ADDENDUM NO. 1

Date: August 11, 2023
Project Name: Runway 18L-36R Pavement Reconstruction
Owner: Denton Enterprise Airport
TxDOT CSJ No.: 2318DENTN
Garver Project No. 23A11280

DRAWING NUMBER
CG-101

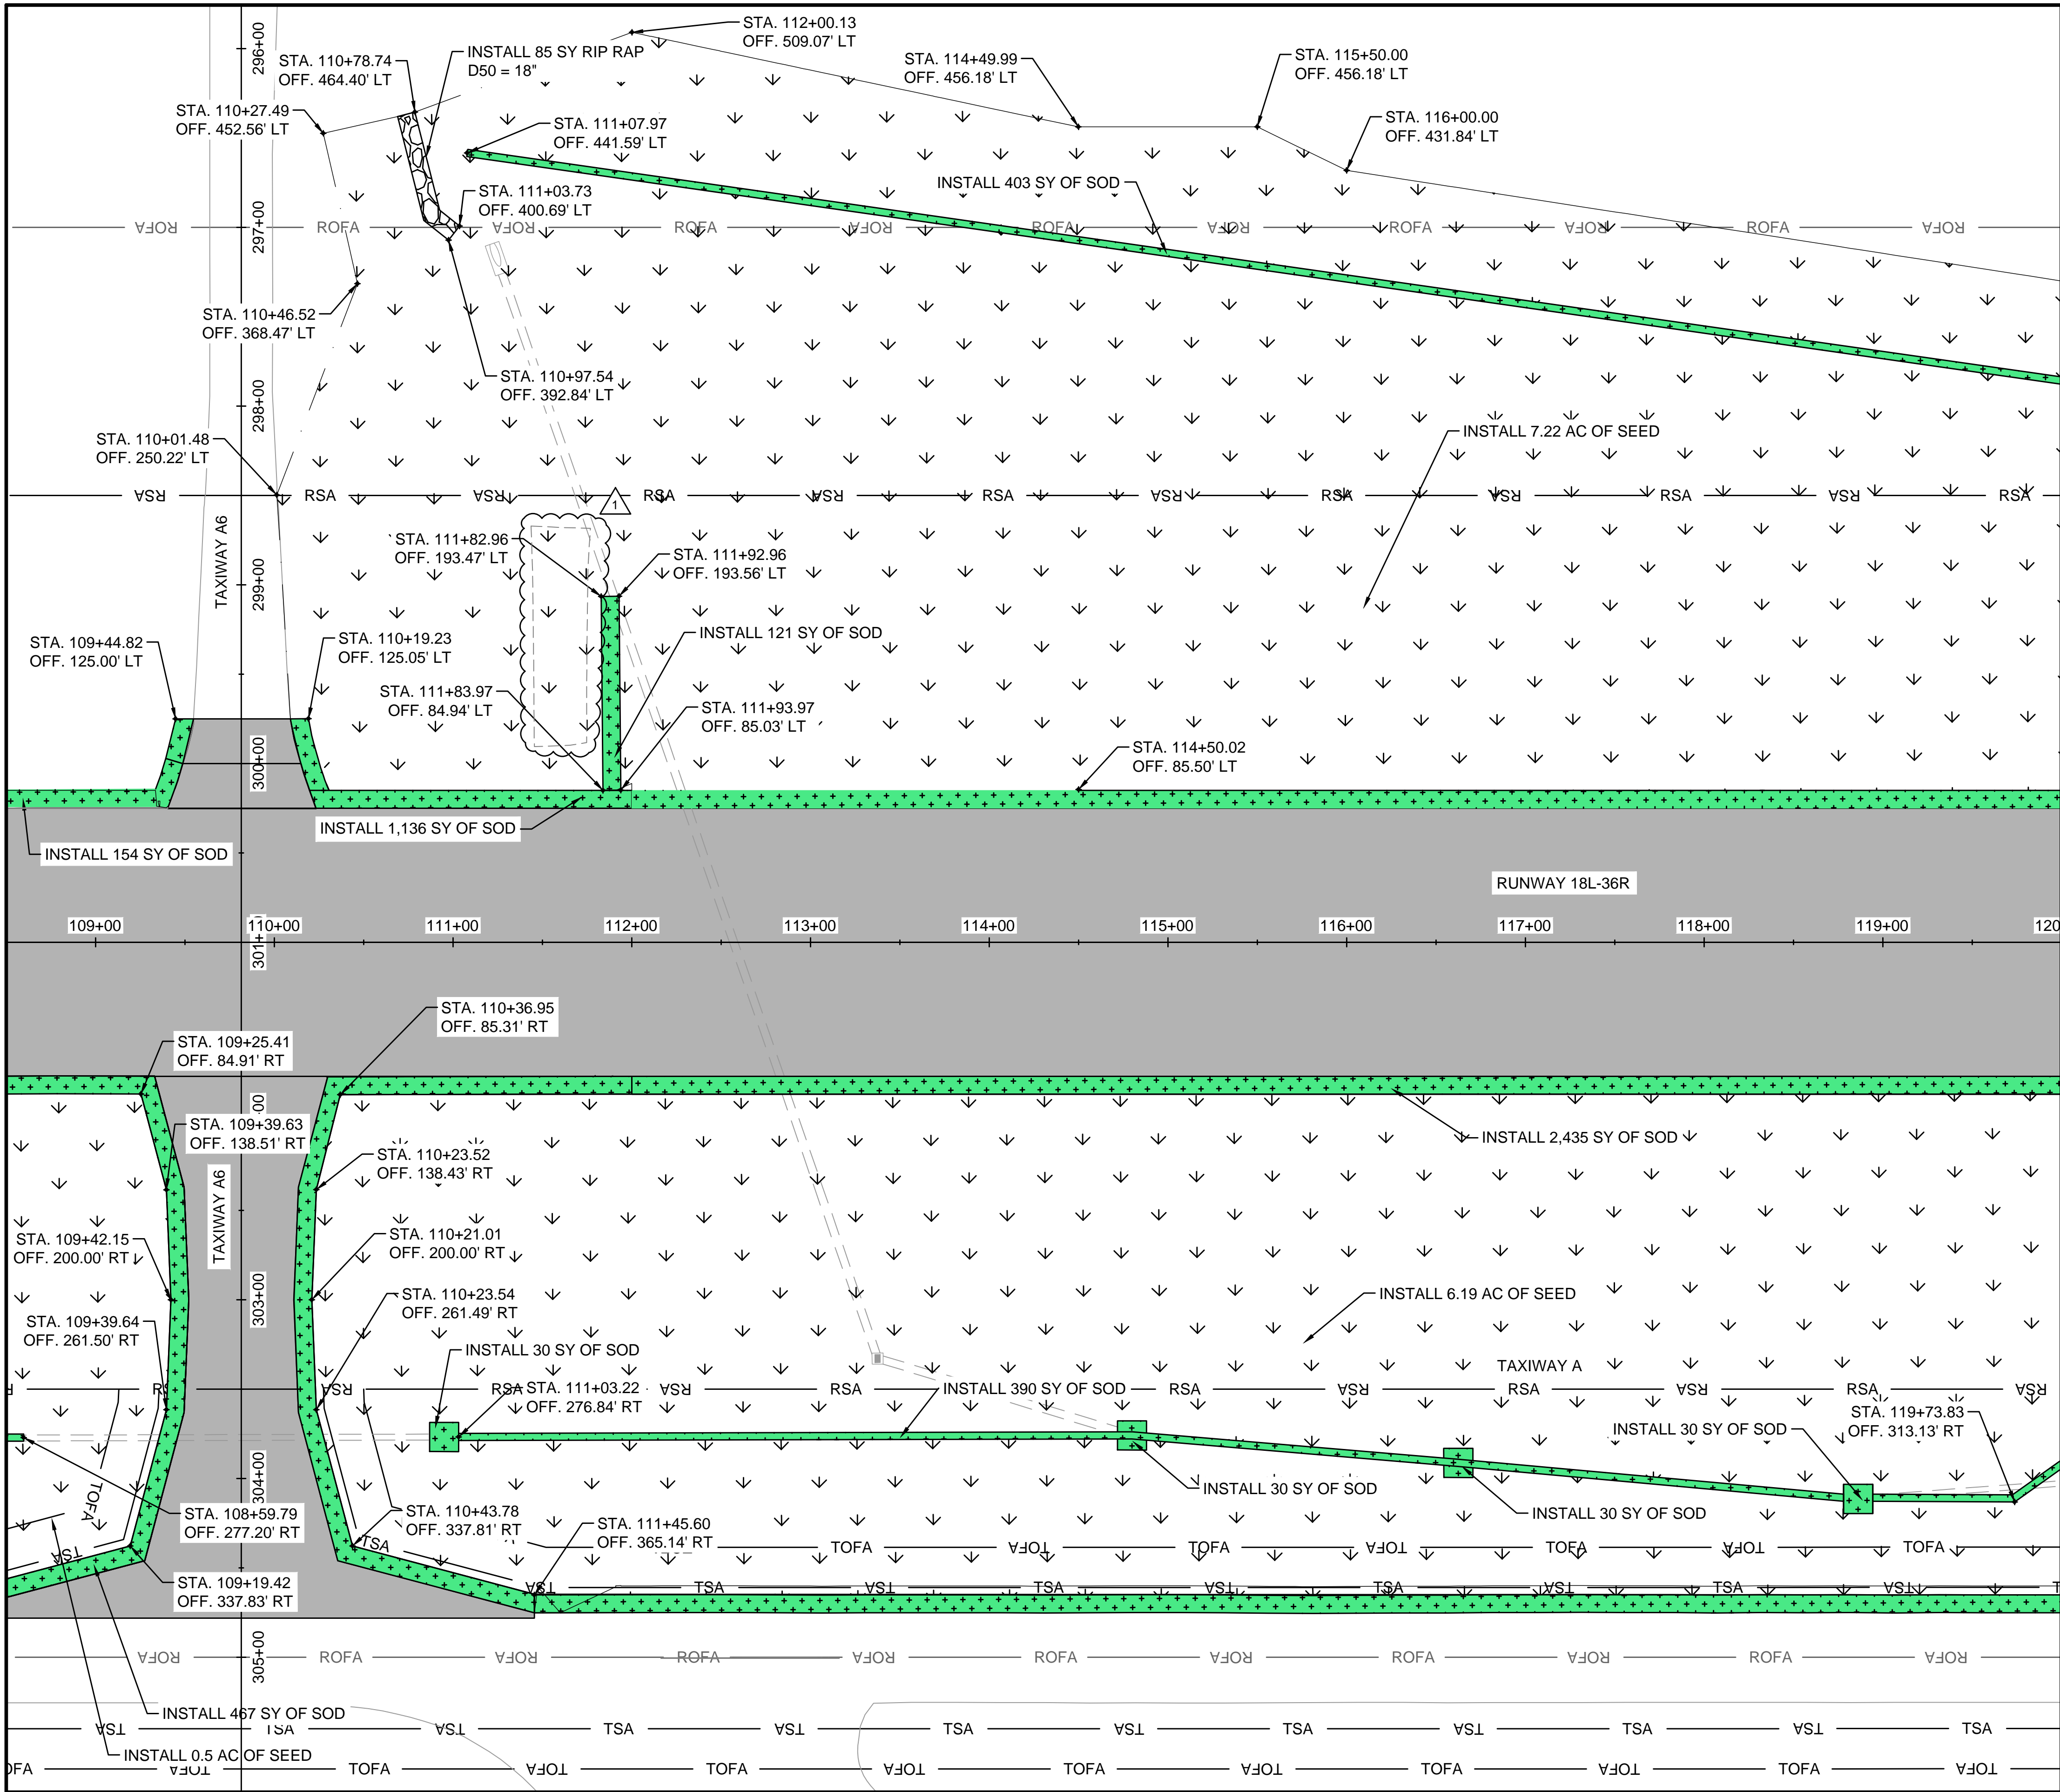
3. Updated Demo Detail of housekeeping pads to be removed around existing PAPI. Sheet "CD-102 Demolition Plan 2"
4. Updated Grading Plans around Existing Survey Monument Locations, Sheet "CG-101 Grading Plan 1"

RESTORATION PLAN 2

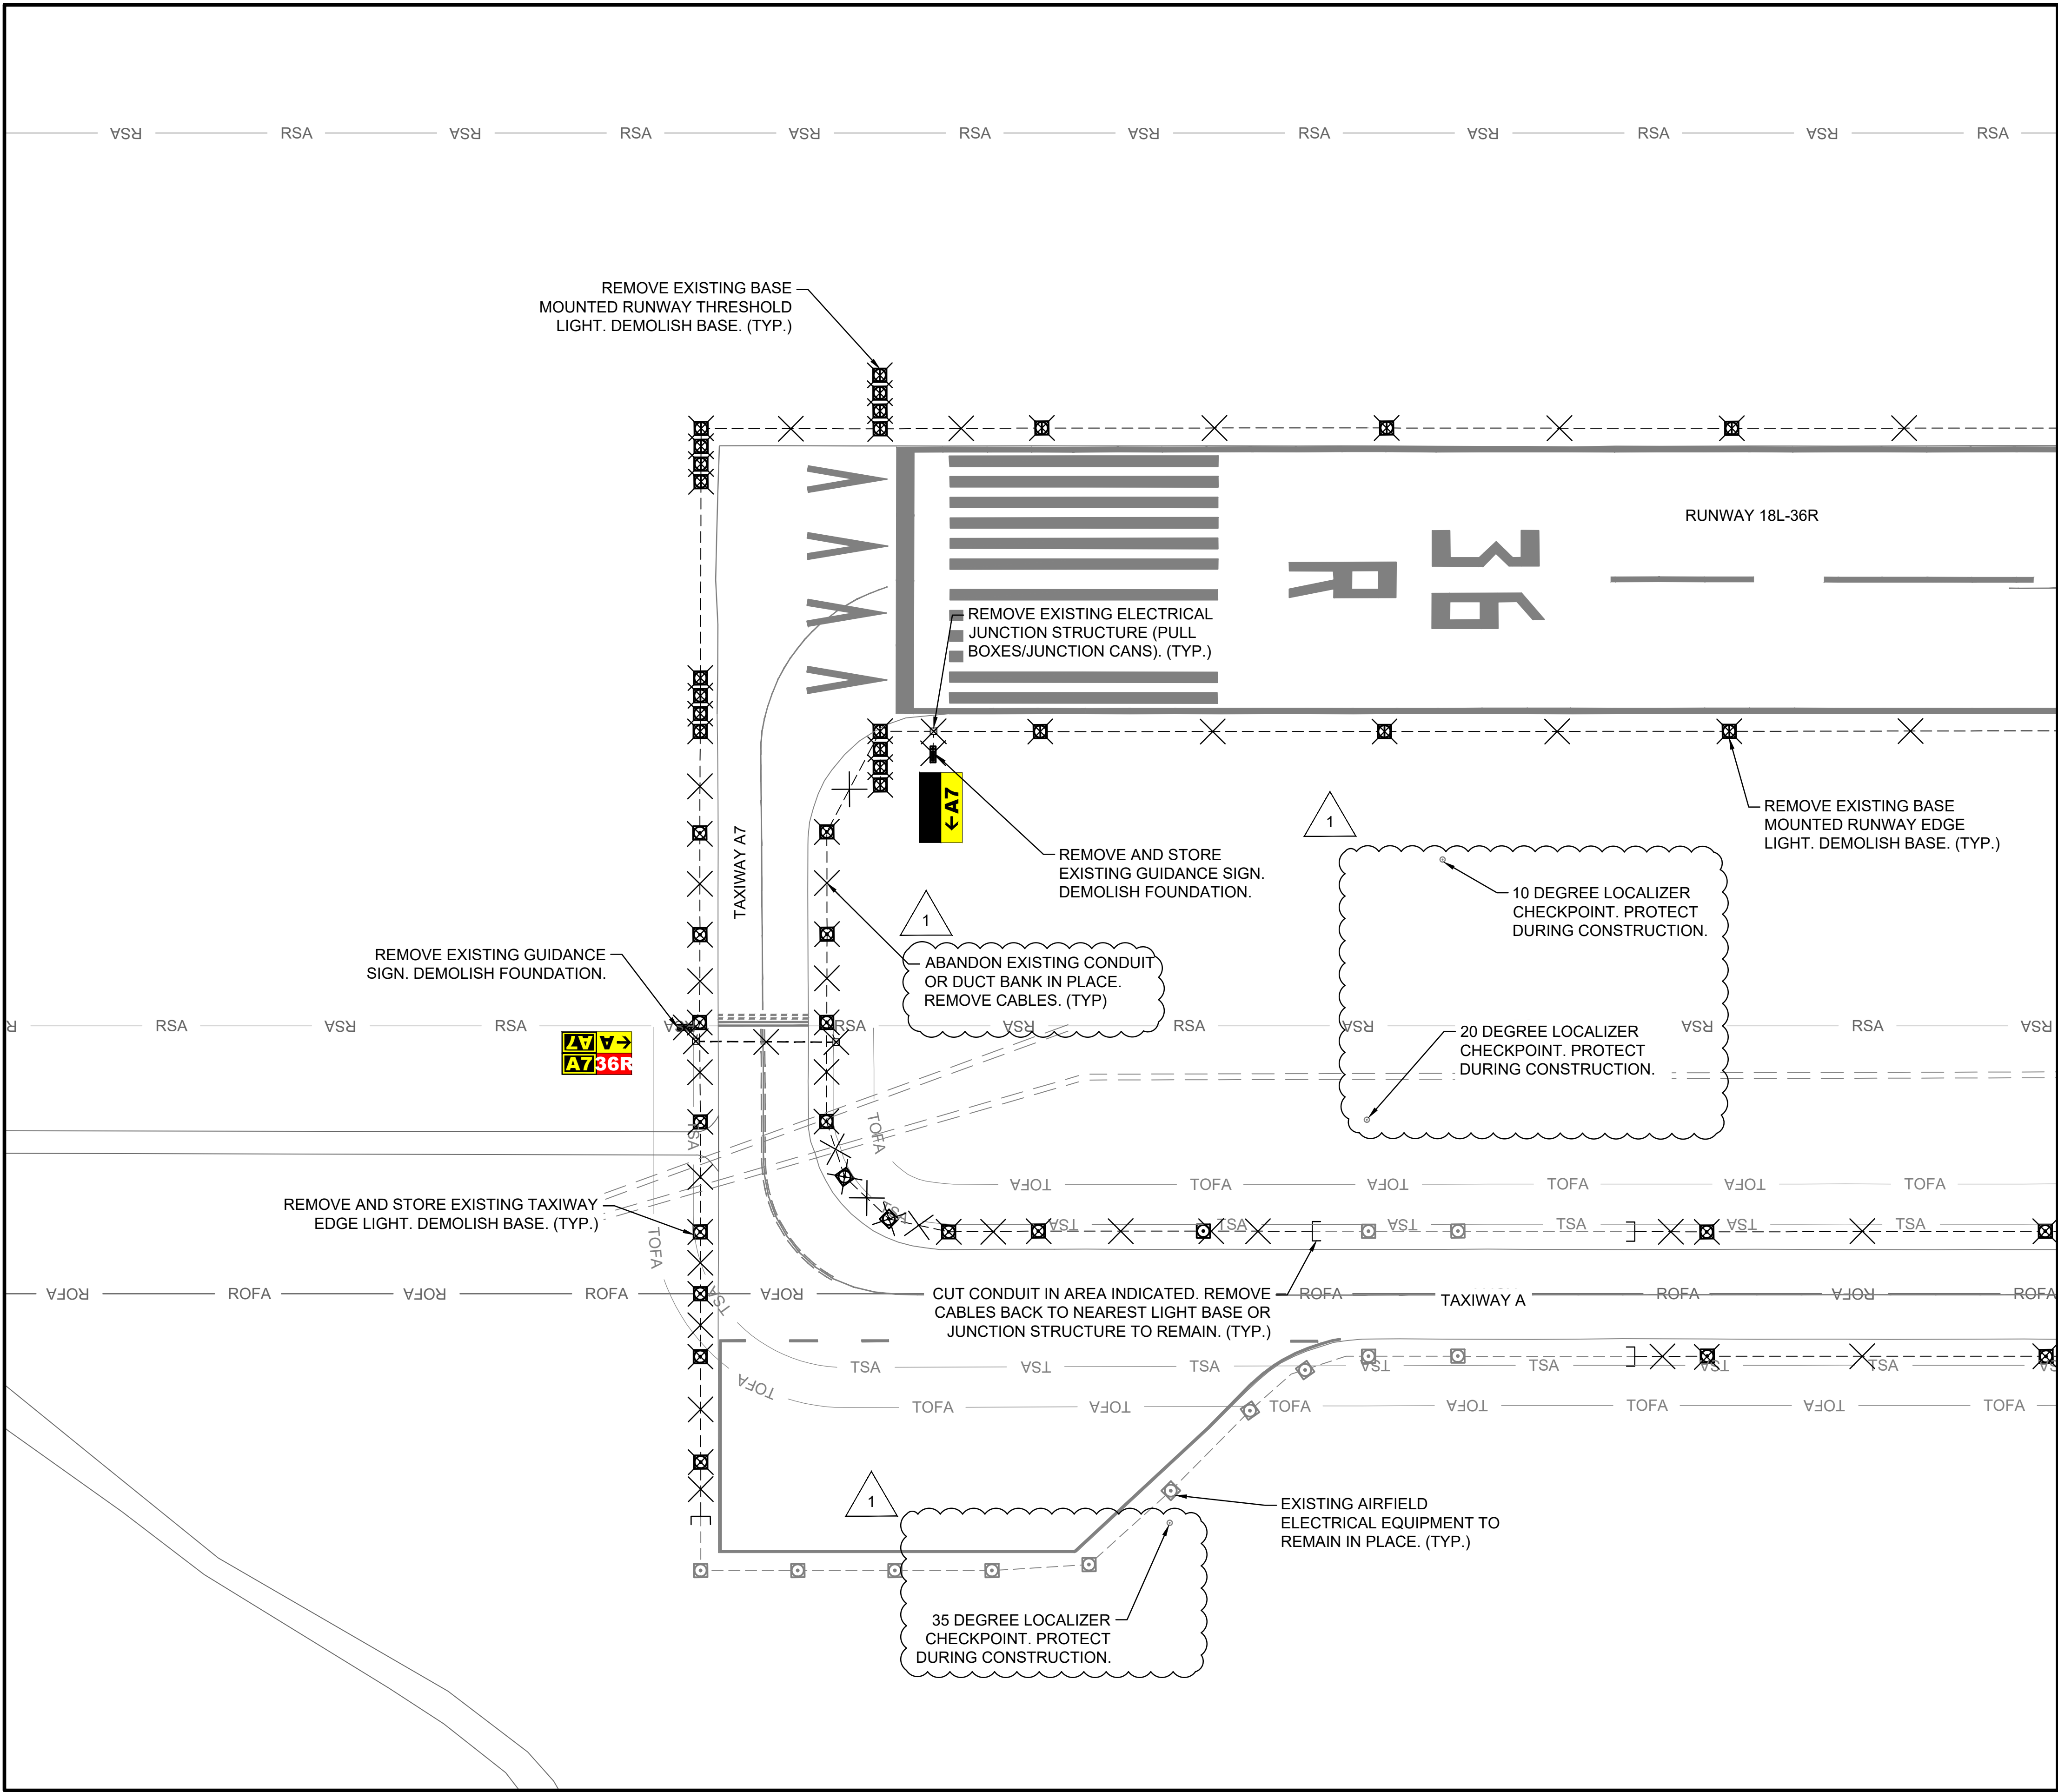
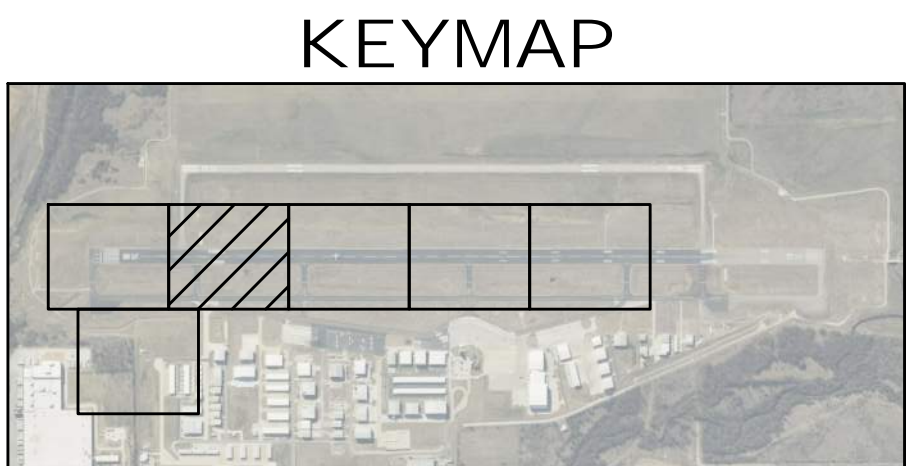
5. Updated Restoration plans of housekeeping pads to be removed around existing PAPI. Sheet "CG-202 Restoration Plan 2"
6. Updated Lighting Removal Plan, updating conduit removal detail, and the PAPI removal. Sheet "ED-101 Lighting Removal Plan 1"
